Work Order ID: 161667

Item Name: Strut Bracket

APICAL INDUSTRIES, INC.	ENGINEERING CHANGE NOTICE NO. 03985			SHEET 1 OF 2	
	DWG NO. 647.0100	REV: A	PREPARED BY J. BECKER	DATE: 7/15/13	EFFECT ON DWG ☐ INC. ☒ UNINC.
	DWG TITLE: SHEET METAL				
	APPROVED BY: ENGR. <i>[Signature]</i>	MFG <i>[Signature]</i>	QC <i>[Signature]</i>	EFF. NEXT ORDER	
TRANSACTION CODES (TC): A-ADD C-CREATE R-REVISE D-DELETE	REASON: REVISED NOTE 2. ADDED 647.0117

SHEET 1, ZONE D1 IS:

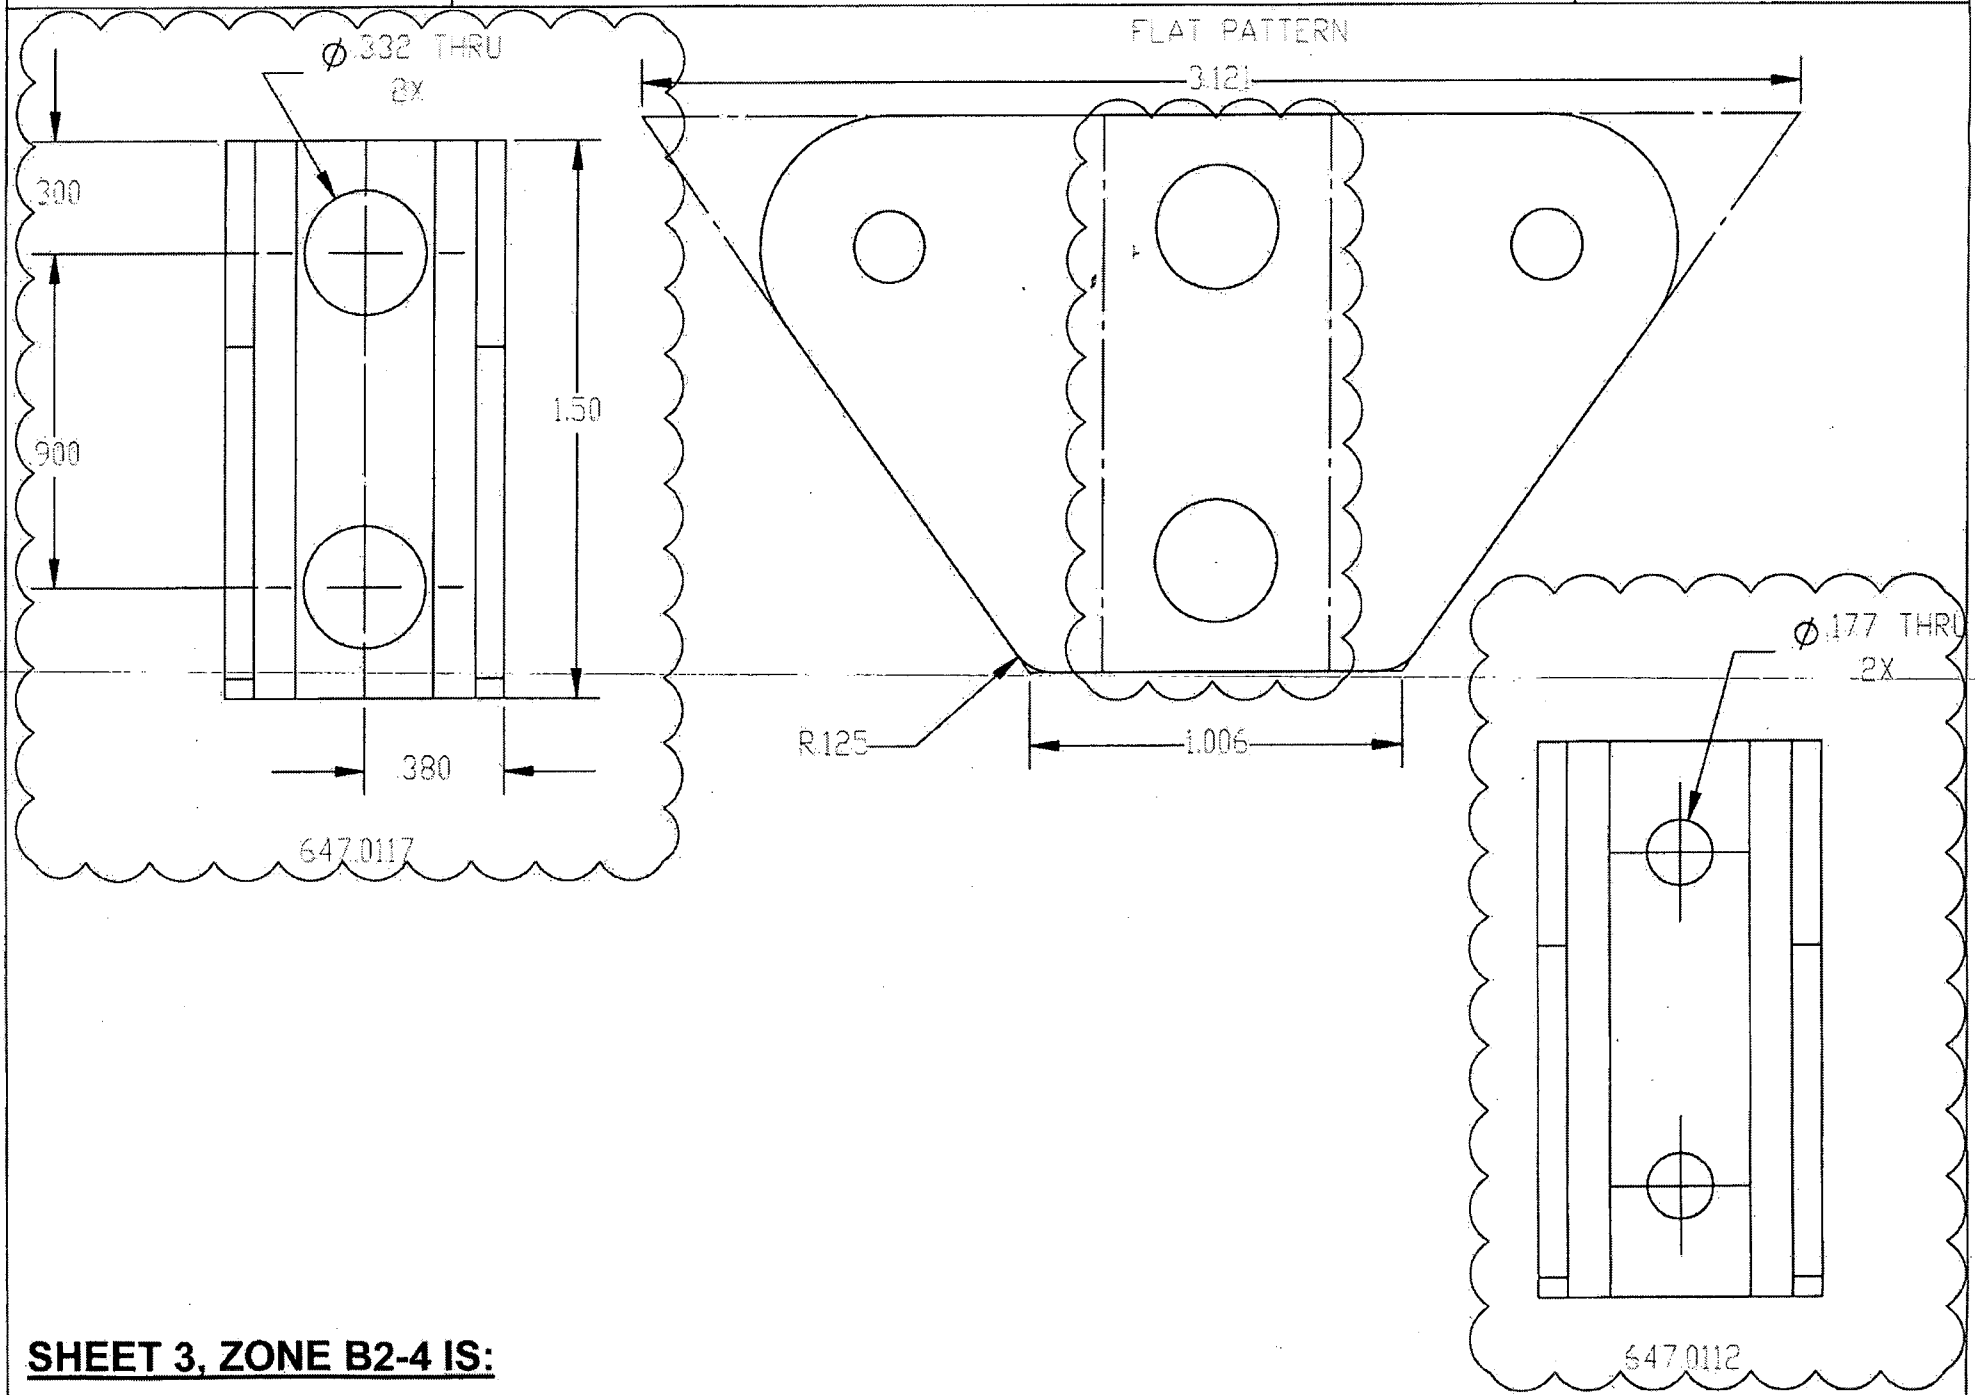
C	647.0117	STRUT BRACKET		△	△
F/N	TC	PART NUMBER	DESCRIPTION	MATERIAL	SPECIFICATION
DOCUMENTS EFFECTED:			CHANGE CATEGORY	DER REVIEW REQUIRED	
☐ MDL ☐ INSTALL INSTRUCTIONS ☐ ICA ☐ FMS ☐ BOM			☐ MAJOR ☒ MINOR	☐ YES ☒ NO

- 1 MATERIAL: ALUMINUM 2024-T3 PER AMS-QQ-A-250/4.
- 2 FINISH: IAW MPP-172 ANODIZE IAW SECTION 2.1, PRETREATMENT IAW SECTION 3.1 AND PRIMER IAW SECTION 4.1.
3. DEBURR AND BREAK ALL SHARP EDGES.
4. IDENTIFY IAW MPP-120.
- 5 MATERIAL: 304 SS IAW AMS 5643.
- 6 FINISH: PRIME IAW MIL-P-23377J TYPE I CLASS N.
- 7 OTHER DIMENSIONS SAME AS 647.0112.
